RESPONSE TO REQUEST FOR ADDITIONAL INFORMATION

APR1400 Design Certification

Docket No. 52-046

RAI No.: 453-8521
SRP Section: 08.02 - Offsite Power System
Application Section: 8.2
Date of RAI Issue: 03/28/2016

Attachment 2: Summary of protective relays operation under OPCs and high-impedance ground fault conditions

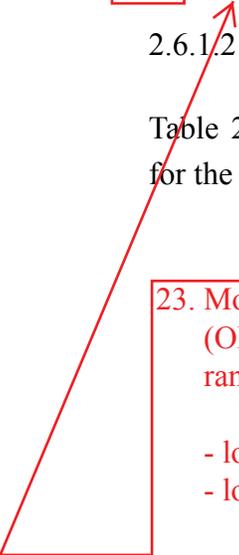
The result of unbalanced load flow (ULF) analysis on the study cases considered is summarized in Attachment 1. The behavior of the existing protection feature for each study case is shown in Attachment 2.

The following provides anticipated effects and consequences on the major electrical equipment and responses of the APR1400 electric power system under the studied cases based on the performed ULF analysis.
